To: Nick Sugar, City Planner and Amanda Krickovich, Community Development, City of Hudson
From: Olivia Hopkins, AIA | Historic Architecture, Perspectus
Date: March 7, 2023
Re: 136 Hudson Street
CC: Lauren Pinney Burge, AIA, Principal & Alice Sloan, Assoc. AIA, APT-RP | Historic Architecture, Perspectus

SUBJECT PROPERTY: 136 Hudson Street

At the request of the City of Hudson, Ohio and per their Codified Ordinances Section 1202.04(b)(3), Perspectus is providing this advisory report to assist the Architectural and Historic Board of Review (AHBR) in their review of the Owner Application requesting alterations to the designated historic property. The following were applied as it pertains to this application under the Codified Ordinances Appendix D. - Architectural Design Standards Section III-2.b.(1):

Image 1: 1950. Courtesy of The City of Hudson.

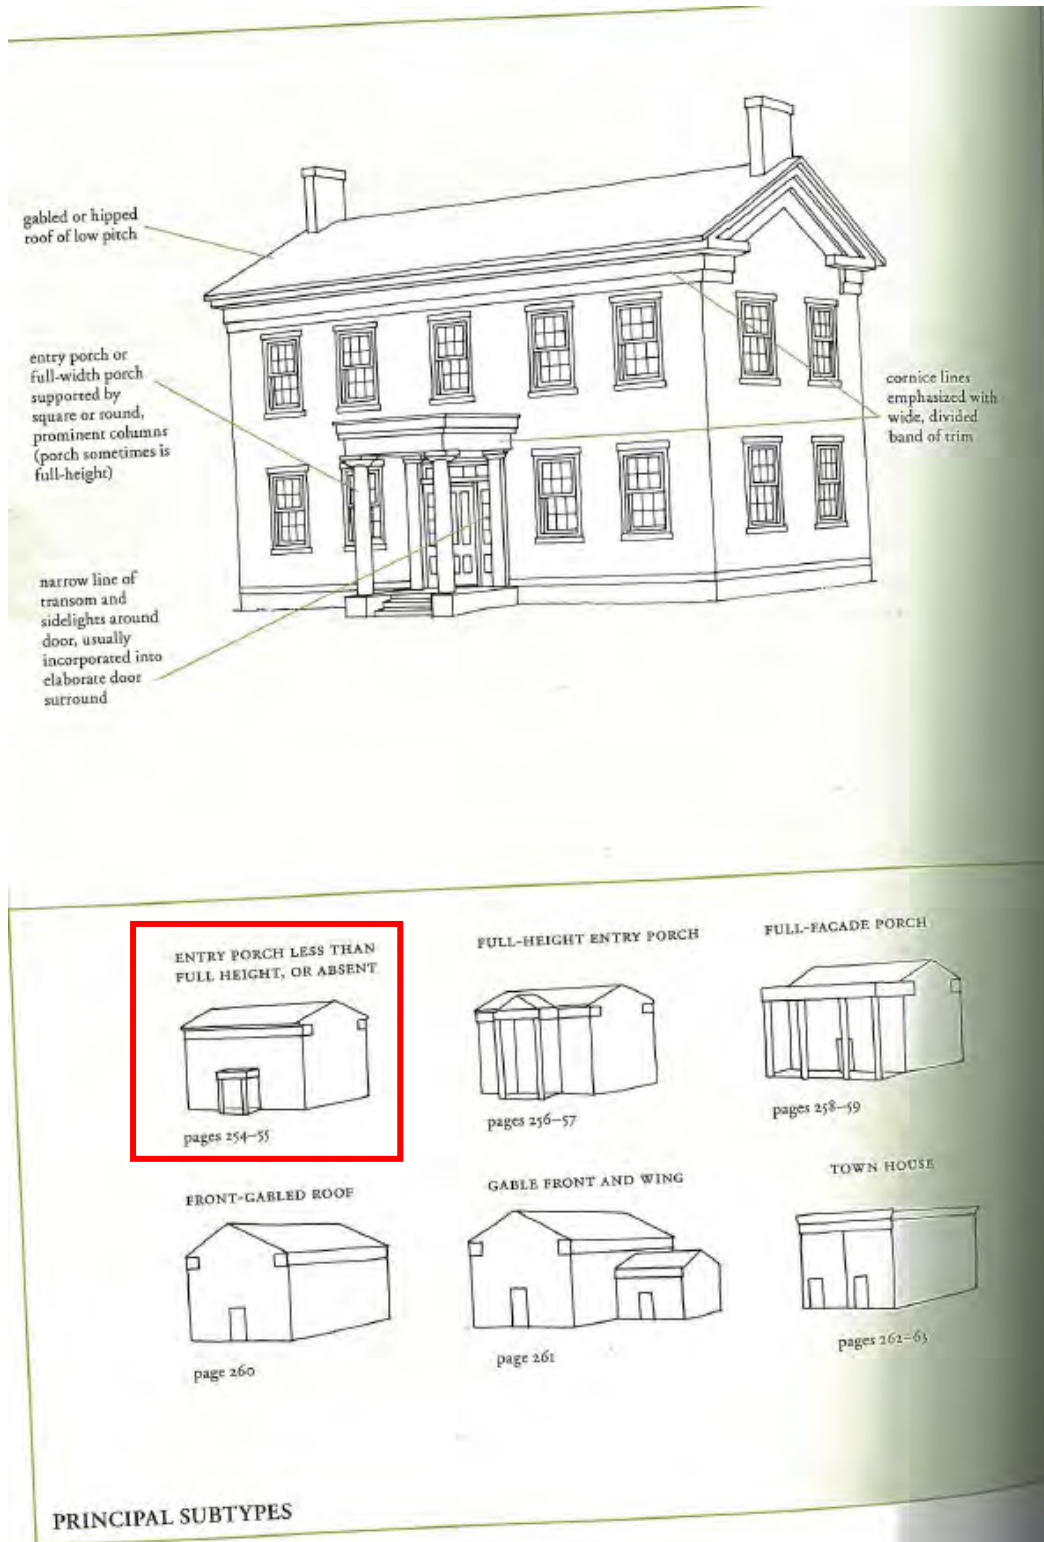
- b. **Change #2:** The canopy (front porch) design should be modified to resemble one of two forms to comply with the Standards:
The first option is to recreate the gable-fronted porch visible in the 1950 photograph included in this report, which meets Standard #6 (replacement of missing features shall be substantiated by documentary, physical, or pictorial evidence). This design is appropriate as it is a previously documented feature and gained historical significance due to the Period of Significance for the district ending in 1963.
The second option is to modify the canopy (front porch) to a configuration typical of houses reflecting the Greek Revival style, as the house is significant under Criteria C as an example of this style. The detailing of the front porch as proposed is appropriate, but the height is not. Note that Ohio is part of the region where a common front porch height is either less than full height or absent (see the images from the McAlester book included in this report). The existing shallow overhang should be removed, and the new canopy (front porch) should align with this part of the façade, just above the door head trim. The low-slope (flat) roof, square Doric columns, and frieze board may remain part of the design.
